# Technical Bulletin

27 07 08 July 18, 2007 2011889 Supersedes T. B. Group 27 Number 06-02 dated Jun. 14, 2006 due to removal from RVU status.

### **No Start, Load Intervention Faults, Electrical Consumers Not Functioning Properly**

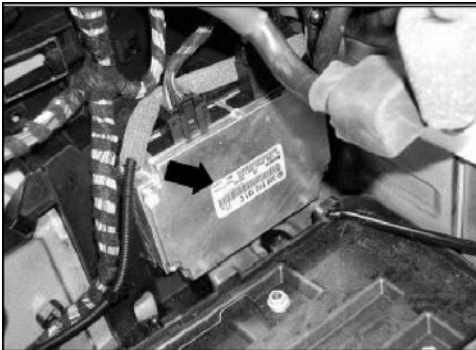
The Battery Manager Control Module -J367- may lose CAN communication and prevent the starter battery from being charged due to a software issue. This condition may also cause the On-Board accessory battery not to charge properly.

As of VIN 3D\_58001151, vehicles will be equipped with updated Battery Monitoring Control Module (software level 2700 or higher).

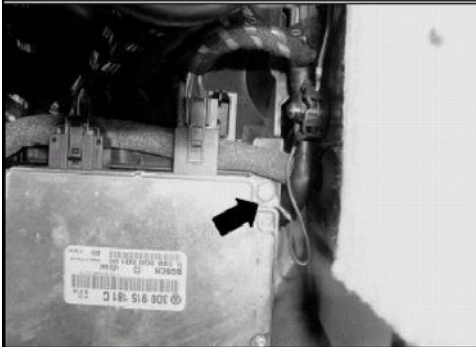
4. Observe the part number label on the Battery Monitoring Control Module -J367-.
5. To the right of the part number you will see the software level. If the software level is 2700 or higher, no further action required.

6. If the software level is less than 2700, replace the Battery Monitoring Control Module -J367-. See repair manual Group 27 – Battery, Starter, Generator, Cruise control in Elsaweb, and continue with bulletin.
